**ROYAL COMMISSION OF INQUIRY INTO BUILDING
FAILURE CAUSED BY CANTERBURY EARTHQUAKES**

THE CTV BUILDING COLLAPSE

**STATEMENT OF EVIDENCE OF MURRAY LIONEL JACOBS IN REPLY
IN RELATION TO THE CTV BUILDING**

Fig. 13 - The layout of Shear Walls affects the Torsional Stability of the Lateral Load Resisting System.

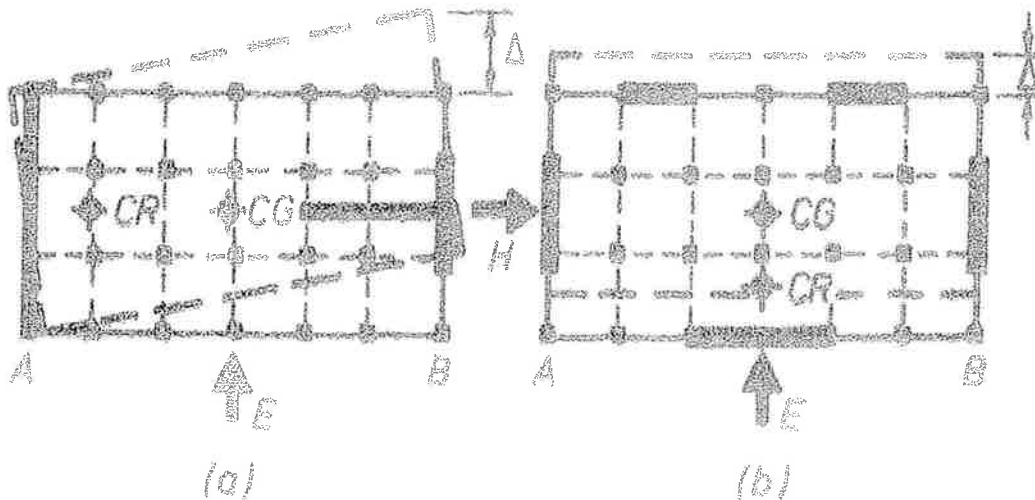
Fig 13 b above shows a more balanced configuration of shear walls with more equal shear walls placed around the periphery of the building and resulting limited torsional loads. This paper reinforces the perils of designing a building with unsymmetrical resisting elements

18. The description of wall A and B in the paper is very similar to the situation of the North and South Shear Walls on the CTV building. Wall line 1 (the South Wall) is as for wall B in figure 13a and wall line 5 (the North Wall) is as for wall A in figure 13a, except wall line 5 in the CTV building is outside the main building floor plate – which is worse.
19. The smaller shear wall (South Wall) could have been subjected to a displacement Δ much larger than expected, as is outlined in this paper. This would mean that the columns in

Plan of typical floor showing arrangements of shear walls.

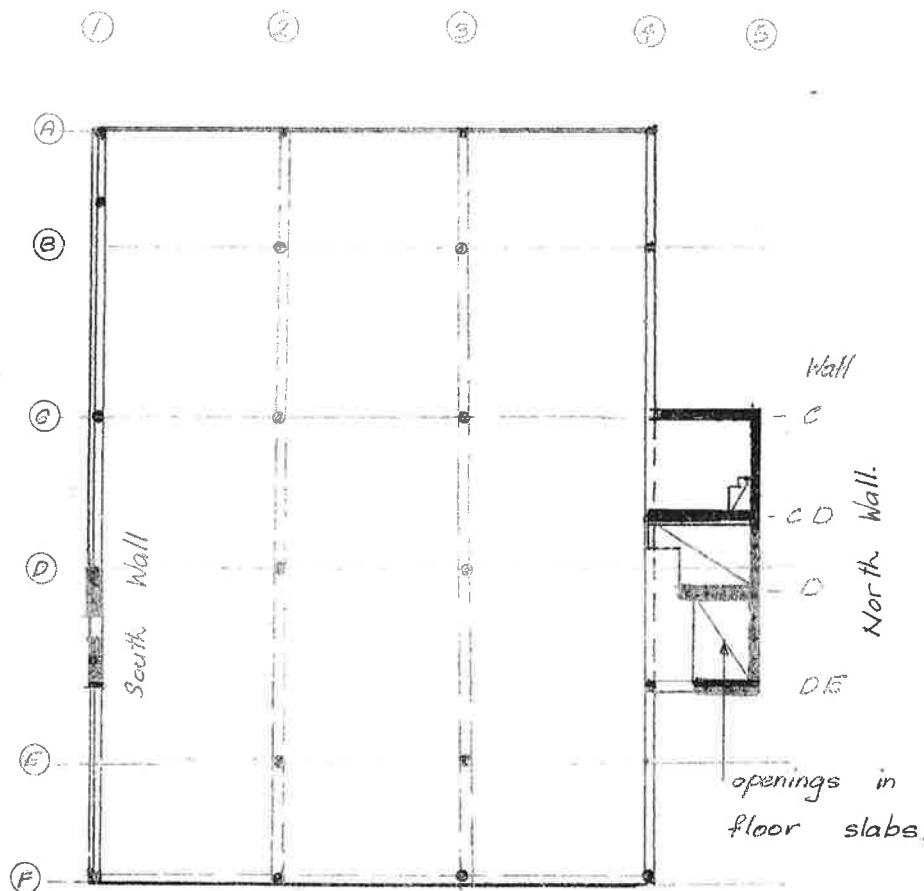
lines (1) and (2) would have also been subject to greater displacements than expected. These columns were brittle. They have not been detailed for ductility. They could only accept a limited amount of deflection before failure. The code has warned many times about the limitations of assumptions, analysis and the uncertainty of the behaviour of unsymmetrical structures. These are the reasons that the warnings and requirements have been outlined. This warning was given in his paper by the Professor of Engineering in Christchurch University many years before the CTV building was designed. It was available in the widely read Bulletin of the NZ National Society for Earthquake Engineering and is reflected in the many instructions in the code about eccentric buildings.

Column design graph from Alan M. Reay consulting engineer calculations page G38

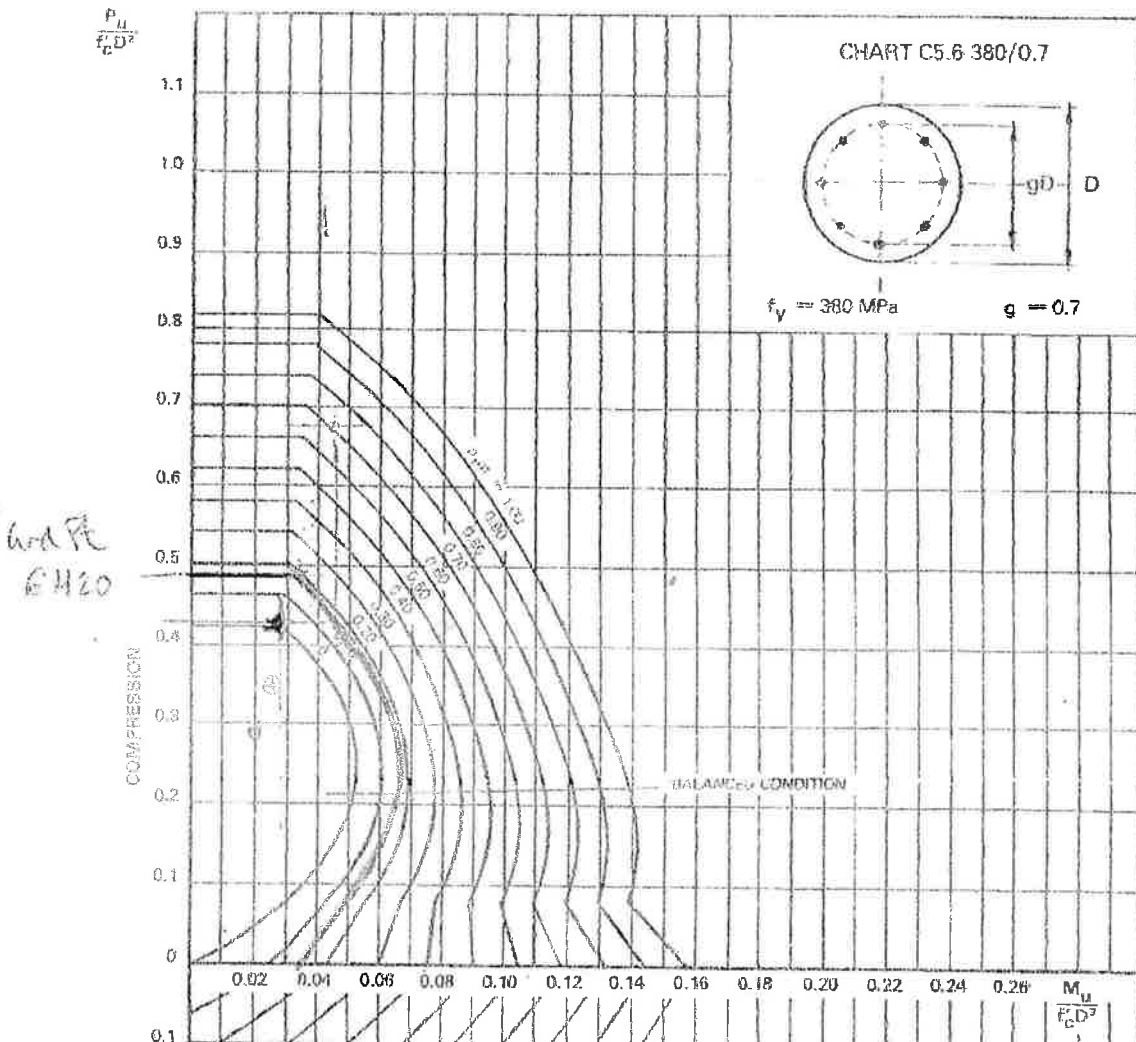
30. The column design chart reproduced below from the design calculations of Alan M. Reay Consultants at page G38 (BUI.MAD249.0273.40) show the design point as a circle at

around 0.43 on the vertical axis and 0.028 on the horizontal axis. This position on the design chart indicates a heavily loaded column with a small capacity for moment. If the moment is plotted on this graph for the design moment calculated from the 3D analysis referred to above, the design point falls well to the right on the horizontal line between 0.4 and 0.5 ordinates, indicating yielding of the column by plastic action.
